### **PHRG DUMPSTER ENCLOSURE JSP26-06**

Consideration at the request of Power Home Remodeling Group for Preliminary Site Plan and Section 9 Façade Waiver approval. The subject property is located at 41370 Bridge Street, situated east of Meadowbrook Road and north of Eleven Mile Road (Section 13). The property is zoned I-1 (Light Industrial). The applicant proposes to construct an accessory structure on the northwest corner of the site.

PHRG Dumpster Enclosure  
JSP26-06  
February 25, 2026

# PLAN REVIEW CENTER REPORT

SHEET  
 Engineered Site Plan

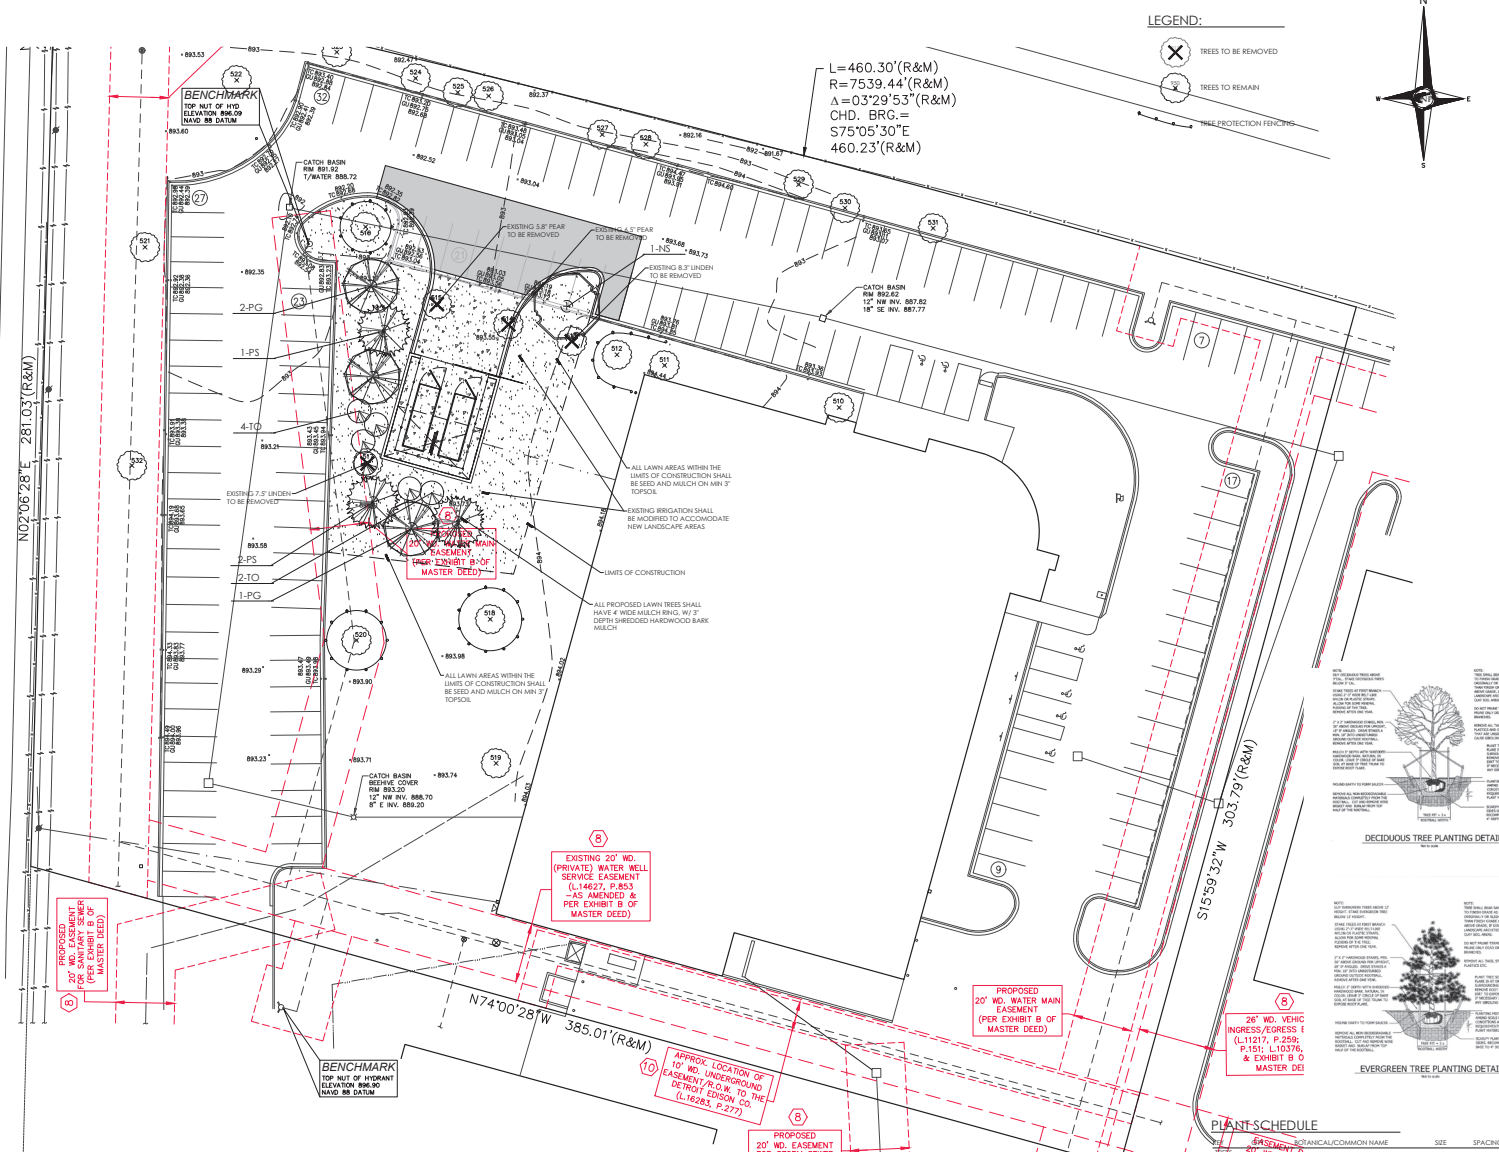
3. Number of Parking Spaces (Sec. 5.2.12.D-E): Professional offices require one (1) space for each two hundred twenty-two (222) square feet of Gross Leasable Area (GLA) for buildings up to 100,000 square feet. Warehouses require one (1) space for each seven hundred (700) square feet of usable floor area. *The existing building is 26,247 square feet and the applicant confirmed in their submittal that the interior use of the building is 18,127 s.f. of office area and 8,120 s.f. of warehouse area. Therefore, the building use would require 93 parking spaces, but the applicant only considered the warehouse use in their total parking calculation. However, even with the proposed removal of eight (8) spaces the total number of parking spaces will be 128 including 6 accessible spaces, well exceeding the required parking.* **Update the parking calculations on Sheet C3 to reflect the total required spaces based on the details provided in italics above on the Electronic Stamping Set submittal. Edit existing building total square feet to 26,247 on Sheet C3 on subsequent submittal as well.**

1. Understood.
2. The parking calculations have been updated on Sheet C3.
3. Understood.
4. Understood.

PROPOSED NEW DUMPSTER ENCLOSURE  
 PLAN, ELEVATIONS AND DETAILS

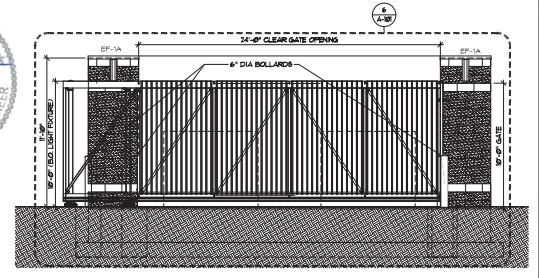
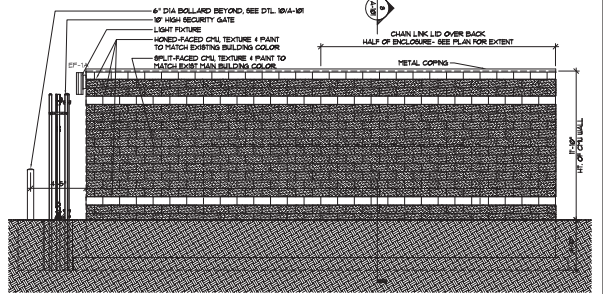
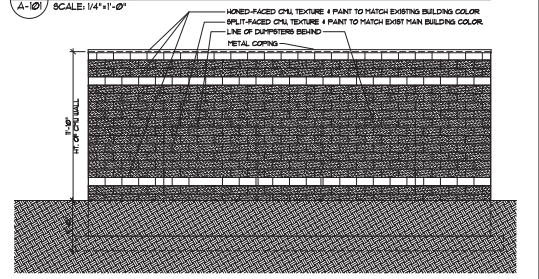
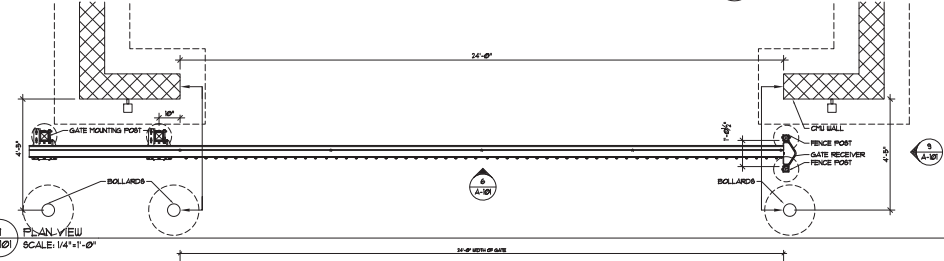
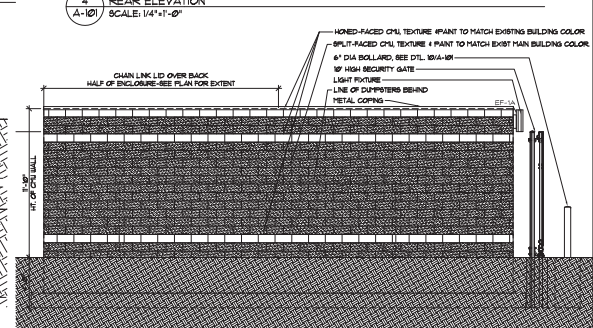
The applicant should clarify that the dumpster door design will provide adequate screening. For example, the spacing of the “1” SQ. x 1/8” WALL PICKET, TYPICAL” should be indicated. We believe 2” maximum spacing would be required.

Question: The applicant should clarify that the dumpster door design will provide adequate screening. For example, the space of the "1" SQ. x 1/8" WALL PICKET, TYPICAL" should be indicated. We believe 2" Max spacing would be required.

Answer: The gate is designed with 1" square pickets spaced with 3.75" between the pickets. We have confirmed that the manufacturer is not able to fabricate the gate with closer spacing. As an alternative, we could provide a chain link gate with diagonal privacy screening, however we believe that would be a less appealing solution.

We would like to work with this specific gate as it is a high-quality estate fence which is both durable and aesthetically pleasing. Therefore, if the spacing between the pickets is determined to be too large, we are recommending a black fence screen be applied to the back of the gate. This will block virtually all views into the dumpster enclosure while maintaining the aesthetic of the estate fence. We recommend the following:

- MAXFlex PVC Mesh - 300 Series Mesh Fence Privacy Windscreen Fabric
- Install full width of gate from top rail to bottom rail, Custom size for exact, tight fit.
- Fasten on back side of gate with color matching fasteners. Stretch taught.
- 80% privacy blockage
- Screen material color: Obsidian Black
- Provide stainless steel grommets at 18" around perimeter, 3 at the corners
